Huawei Technologies Co.,Ltd.

Huawei Inverter - AS4777.2:2020 Firmware Compliance Update

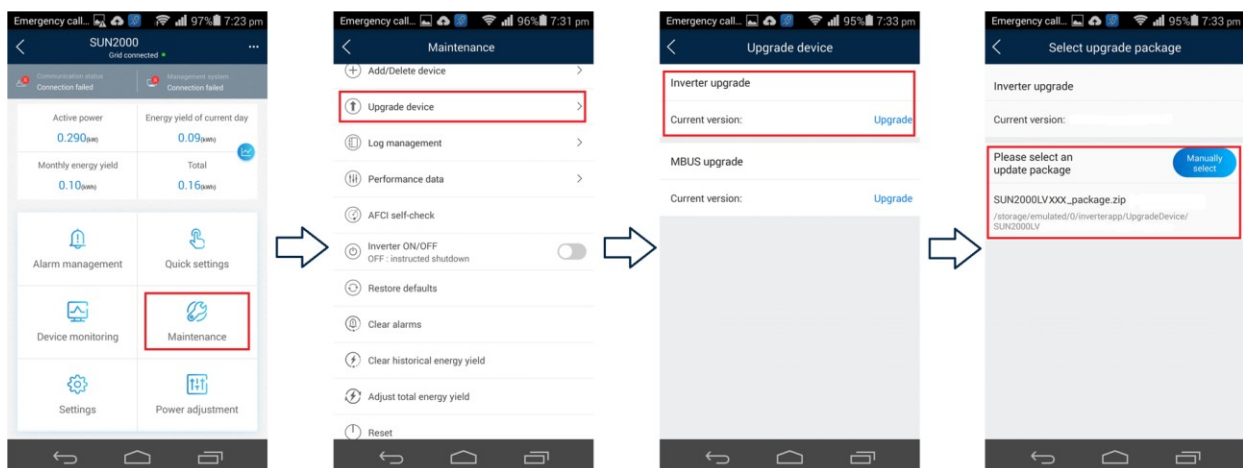
For SUN2000-50KTL-M0 and SUN2000-100KTL-M1, these two models has to be manually upgraded to following version to guarantee inverters comply with AS4777.2 2020 standards which takes effect from 18th DEC 2021.

Manual firmware update can be completed through Maintenance > Upgrade Device > Inverter Upgrade > Select V300R001C00SPC127 for 50KTL-M0 or V500R001C00SPC120 for 100KTL-M1 as Target version.
